SERVICE INFORMATION

Bulletin Nbr: 811-1989
Date:.....December 1998
Market: all

The soft top does not open.

Saab 9-3 CV M98 up to and incl. chassis no. W7054661 respective X7002303.

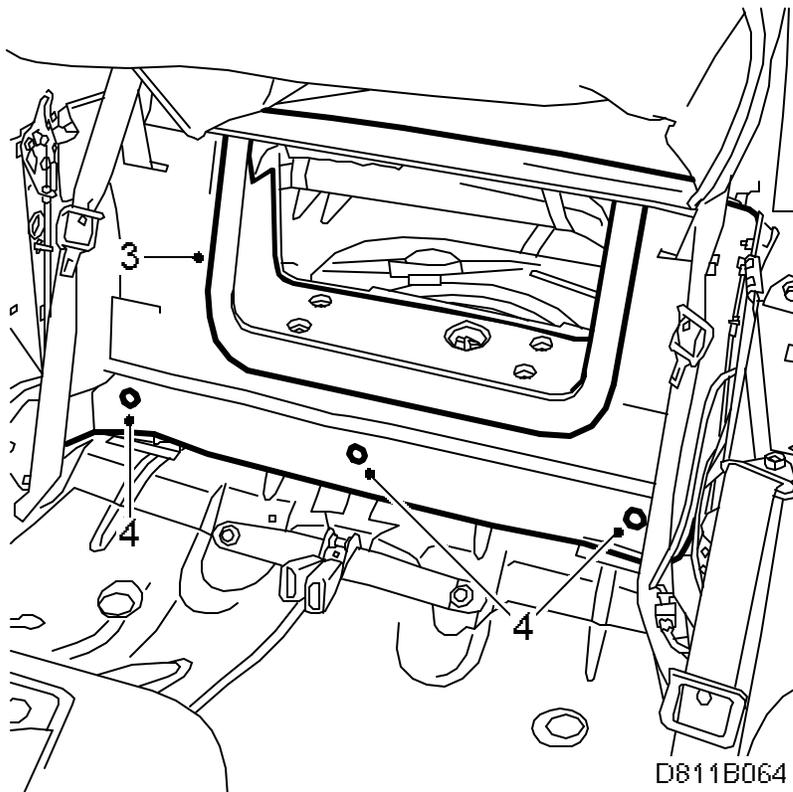
The problem is rectified by changing to a new, stronger and more flexible cables. The friction is thus decreased.

In addition, the mounting of the cables to the chassis is also changed.

- 1) 51 11 653 Cable, left side (CA: 30577776)
- 2) 51 11 661 Cable, right side (CA: 30577777)
- 3) 85 30 917 Cable clips (2 pcs) (CA: 30514349)
- 4) 85 52 663 Cable ties (2 pcs) (CA: 30514976)
- 5) 48 07 939 Cable ties (1 pc) (CA: 30514976)

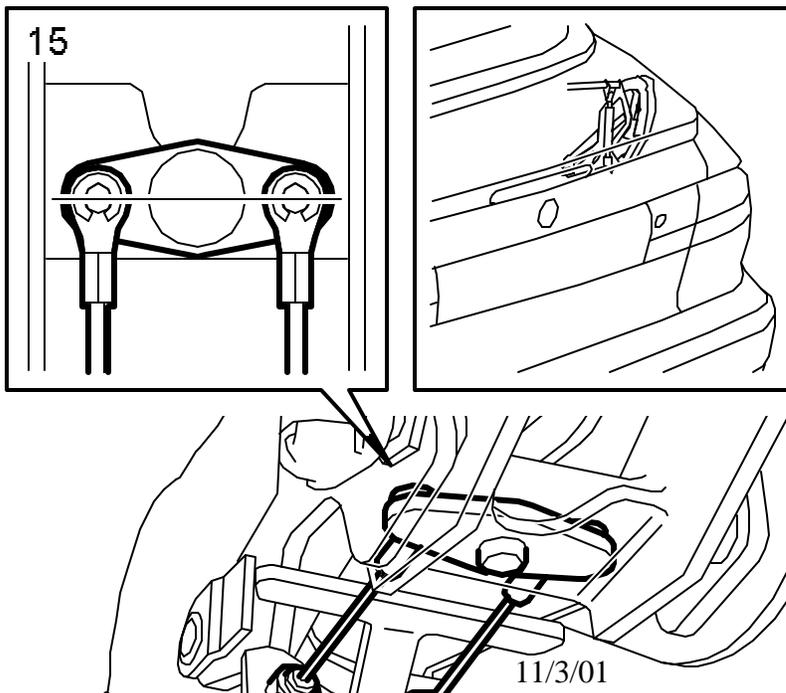
12. Fit the cables to the lock for the soft top cover. →

13. Fit two cable clips (part no. 85 30 917).

14. Fit two cable ties (part no. 85 52 663) and new fabric-backed tape.

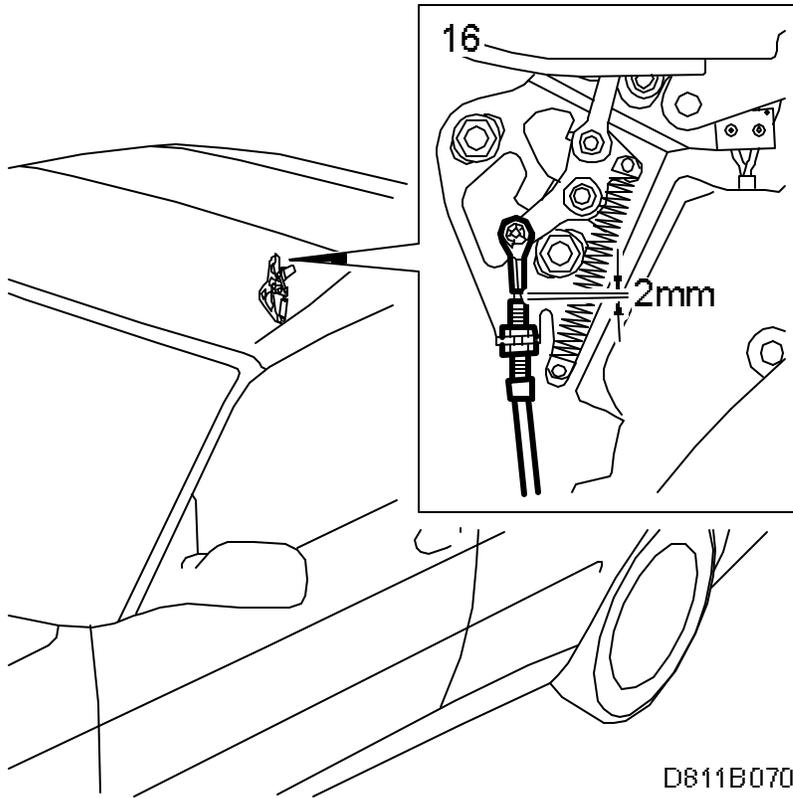
15. Adjust both cables for the soft top cover so that the lever on the drive mechanism is horizontal when the lock is locked.

D811B070

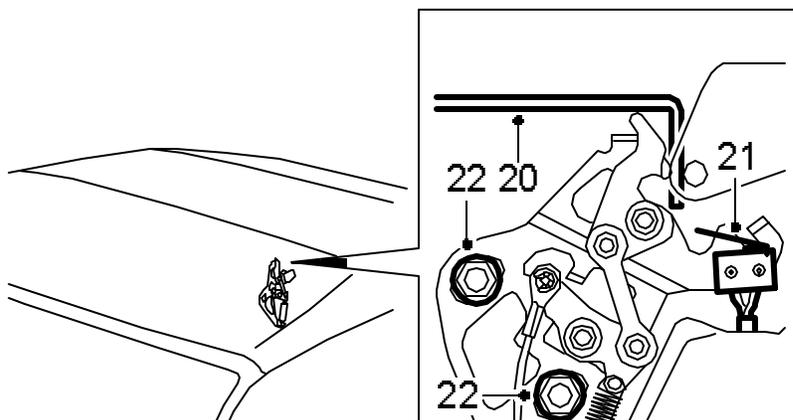
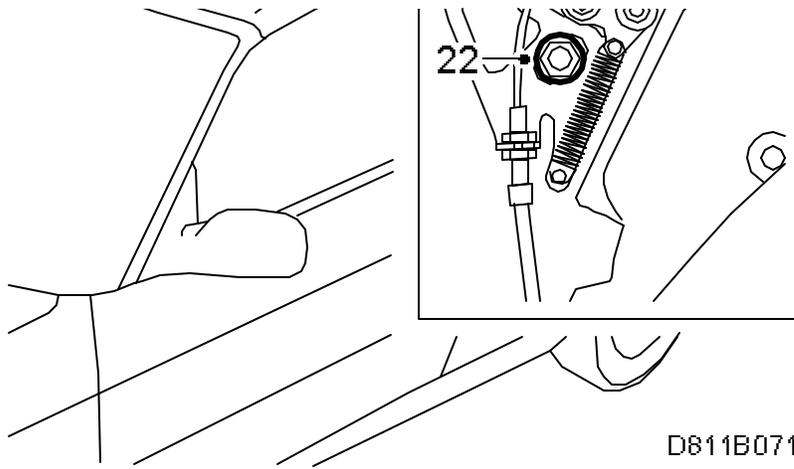
- 16. Check that the distance between the cable adjustment and the end of the cable is at least 2 mm.

- 17. Adjust the cable using the cable adjustments by the locks.
- 18. Check that the locks open completely.
- 19. After fitting the new cables, also check the lock for the soft top cover and, if needed, adjust.

This adjustment is very important since the lock fitting can hook onto the lock which means that the lock pin in the soft top cover drive mechanism can break.

- 20. Raise the soft top cover so much that special tool 82 93 177 can be fitted as shown in the illustration.
- 21. Check that the soft top cover lock fitting enters the lock easily without touching the tool. Listen for a "clicking" sound when the microswitch is activated. If the lock fitting touches the lock, the lock must be adjusted forward in the car.

Loosen the two nuts that hold the lock and press the lock forward. Tighten the nuts.

Return to step 20 and check the adjustment.
